Title: Permit #24-544: Idyllvale Shores Development, Orono

Prepared by: Abigail Couture, Permitting Technician
(952) 641-4587
acouture@minnehahacreek.org

Recommendation:

Approval of MCWD permit application 24-544 with the submitted plans and on the following conditions:

DRIVEWAY CROSSING ANALYSIS FIG 1

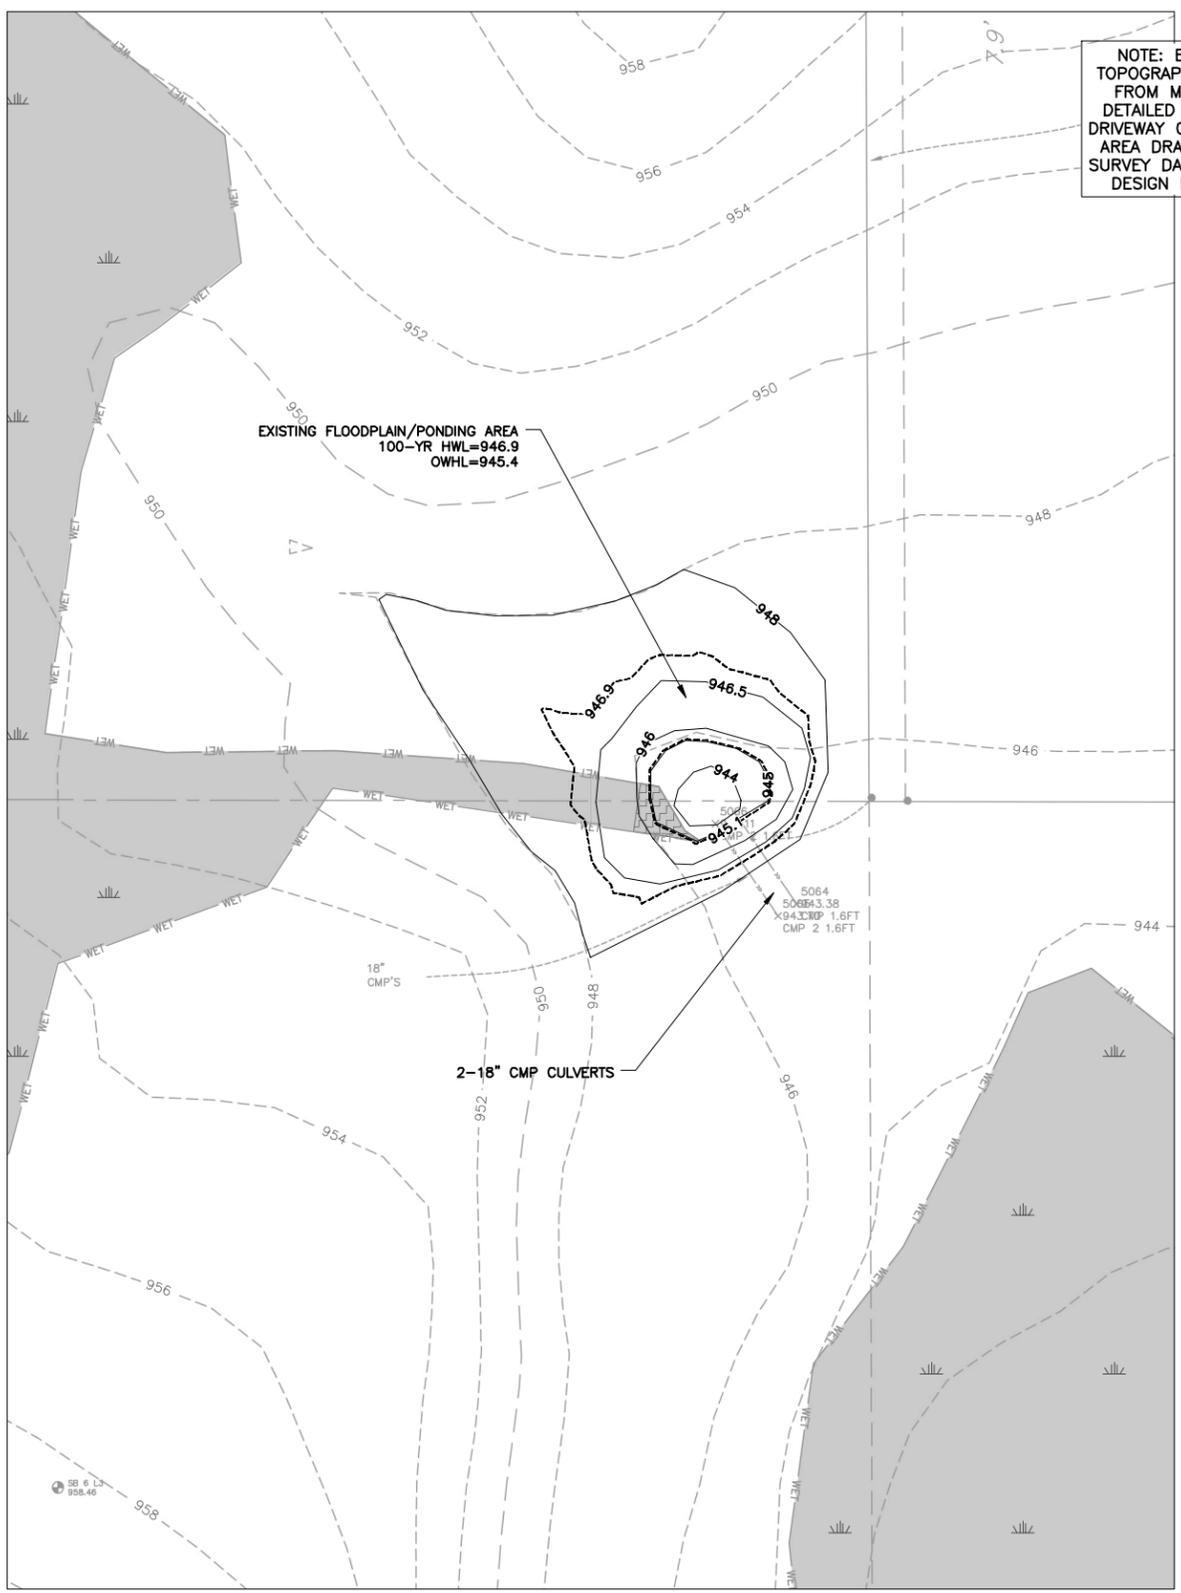
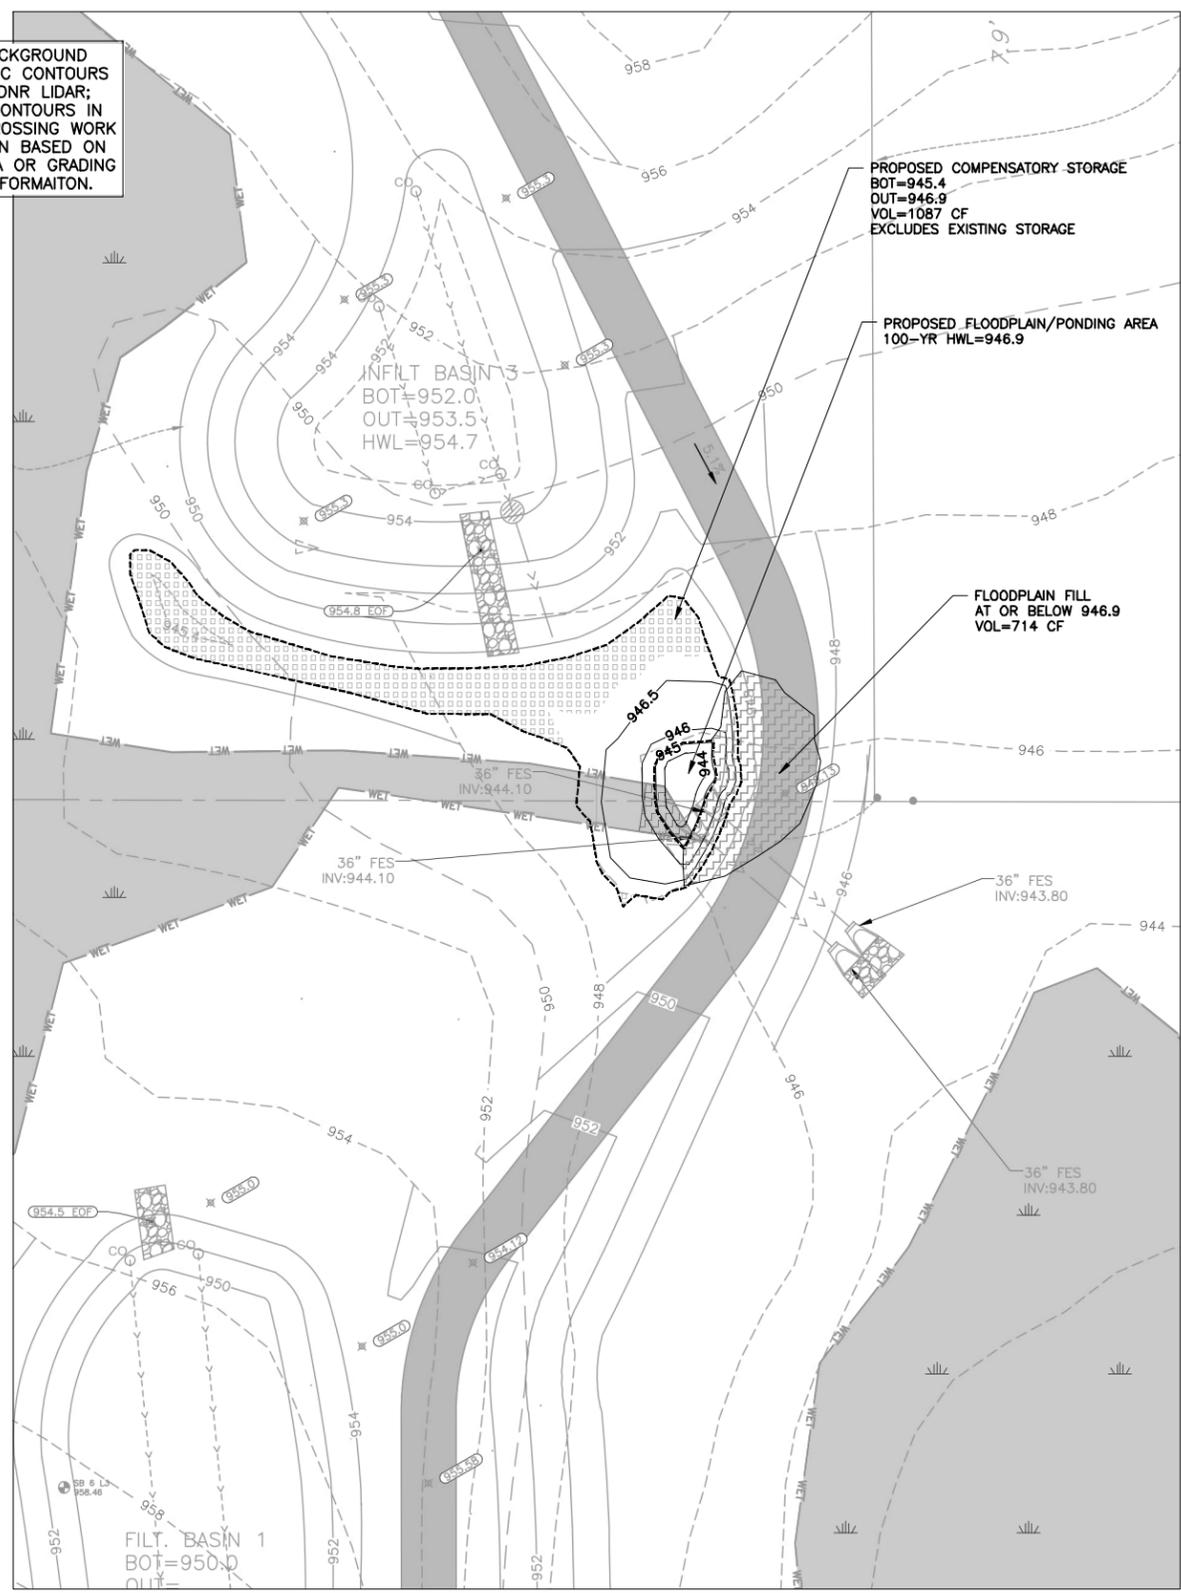
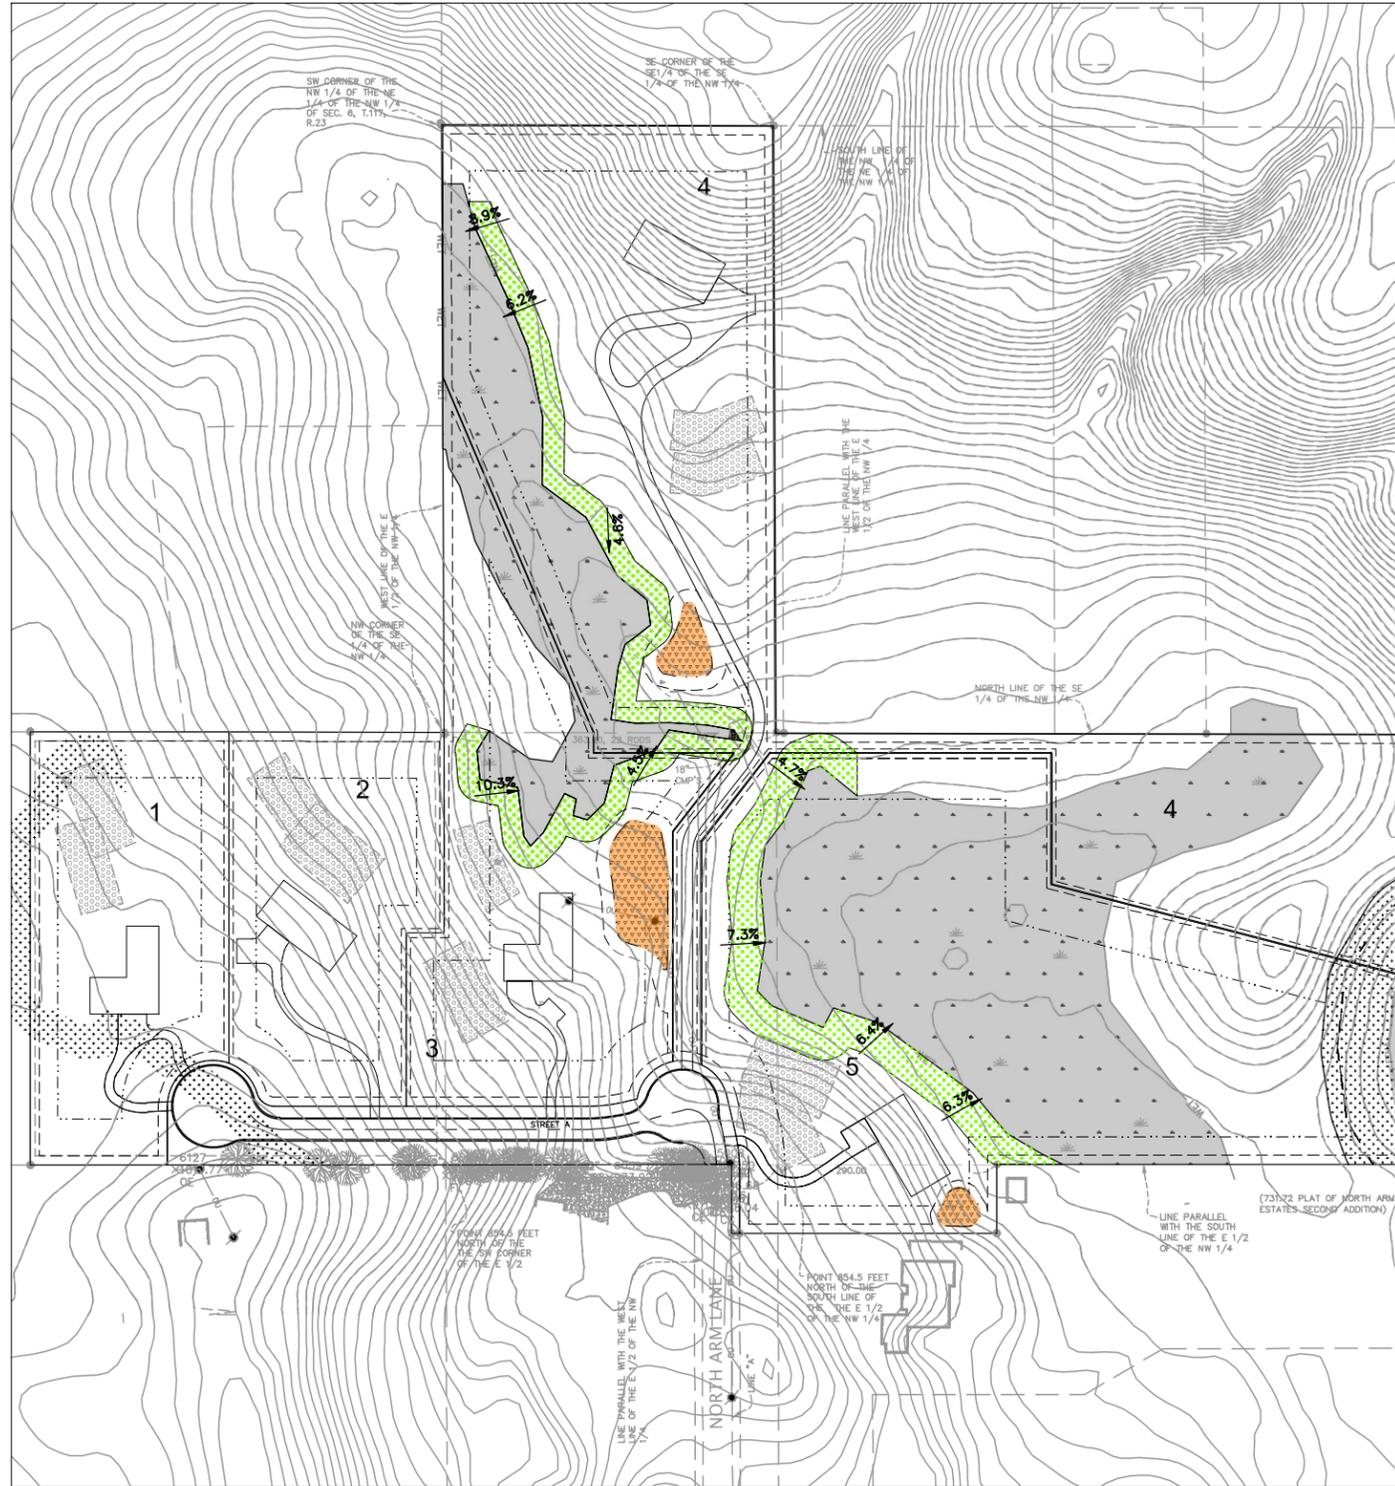
upstream of the culvert on the north side of the wetland, as shown in Figure 1 in Attachment B. This cut will result in the creation of 13.82 cubic yards (373 cubic feet) of net floodplain storage.

2. Applicant must meet the No-Rise Standard: The Applicant has submitted HydroCAD models showing that the proposed culvert and associated fill meets the No Rise Standard by not increasing the 100-year high water level by more than 0.00 ft from the existing to proposed condition. As shown in Table 1 (above), the 100-year high water level is shown to decrease upstream of the culvert and not change downstream of the culvert.
